Comments on Arkall Farm housing development FRA

Application Reference 14/00516/OUTMEI

Risk of Flooding from Surface Water

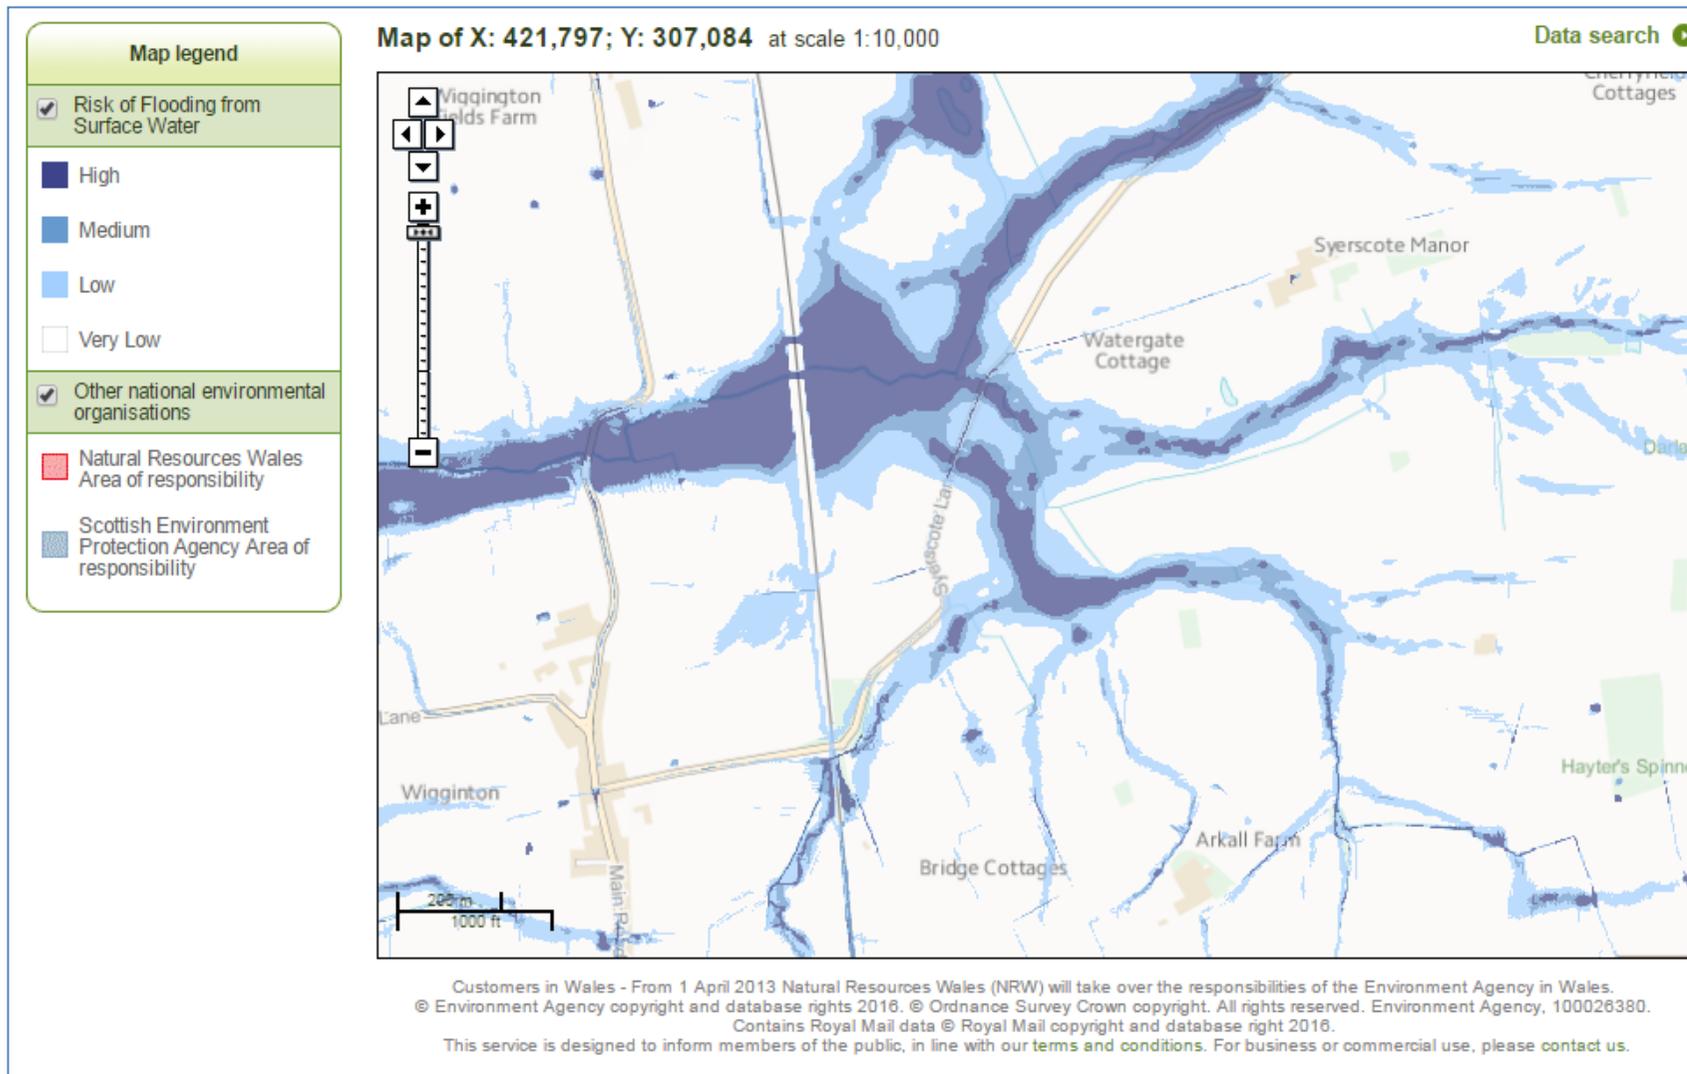
8. Section 3.4 reviews data provided by the EA on surface water flooding. The 1 in 30 year and 1 in 200 year storm event maps indicate flooding close to Syerscote Lane to the north of the proposed development. In fact the lane floods quite frequently after storm events with a probability much

higher than 1 in 30 years. The photographs below, taken on 28th March 2016, show flooding of the lane due to overtopping of the banks of the west “ditch”. This followed wet weather during the previous 2 – 3 days. In view of the shortcomings of the proposed drainage scheme, outlined above, the risk of Syerscote Lane flooding could increase.

Flooding in Syerscote Lane (SK 21553 06843)

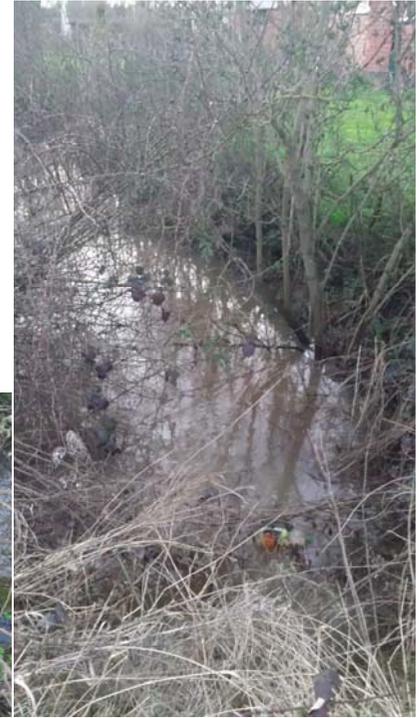
10. The property Watergate Cottage lies downstream of both the West and East ditches which take runoff from the proposed development. This area already has a chance of flooding of greater than 1 in 30 (3.3%). Given the uncertainties outlined above in the FRA, there is a risk that the proposed development will exacerbate flood risk of this area and pose an increased risk to the property. The photograph below, taken on 28th March 2016 after 2 – 3 days of wet weather, shows that the watercourse adjacent to the property was already at a high level.
